RE CASES: **24-DR-2022& 3-IP-2022**
Viva Ananda

The Planning & Development Services Division has completed the review of the above referenced development application submitted on 11/15/22. The following **2nd Review Comments** represent the review performed by our team and is intended to provide you with guidance for compliance with city codes, policies, and guidelines related to this application.

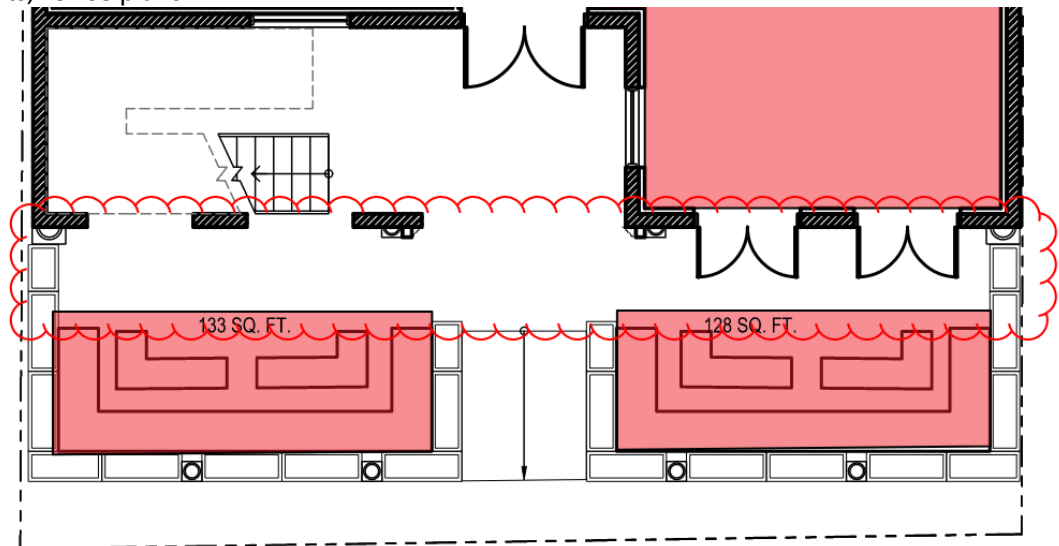
1. Please revise the parking calculations on the site plan and parking plan accordingly per Table 9.103.B. Schedule of Parking Requirements in the Downtown Area.

Restaurants use this ratio:

- A. One (1) parking space per three hundred (300) square feet of gross floor area; and
- B. One (1) parking space for each three hundred fifty (350) gross square feet of outdoor patio area. Excluding the first three hundred fifty (350) gross square feet of outdoor patio area, unless the space is located next to and oriented toward a publicly owned walkway or street, in which case the first five hundred (500) gross square feet of outdoor public floor area is excluded.

Personal care services use this ratio:

- B. In a Type 2 area, all other lot widths, one (1) space per three hundred (300) square feet of gross floor area.

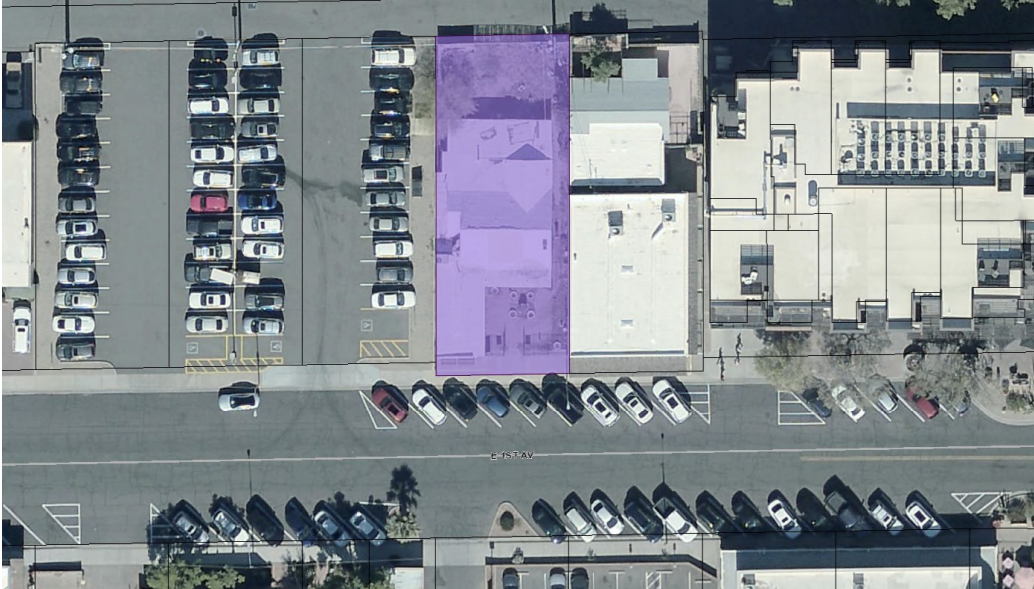
13. The City's Sensitive Design Principles and Old Town Scottsdale Urban Design & Architectural Guidelines (OTSUDAG) promote the use of muted earth tones in applied materials and paint colors. Please revise the project plans and material board to incorporate building colors that meet these design guidelines. **The colors have been updated, but the gray accent of Dunn Edwards "At First Light" lacks color tone and should be updated with a warm, taupe-like color. Please revise.**
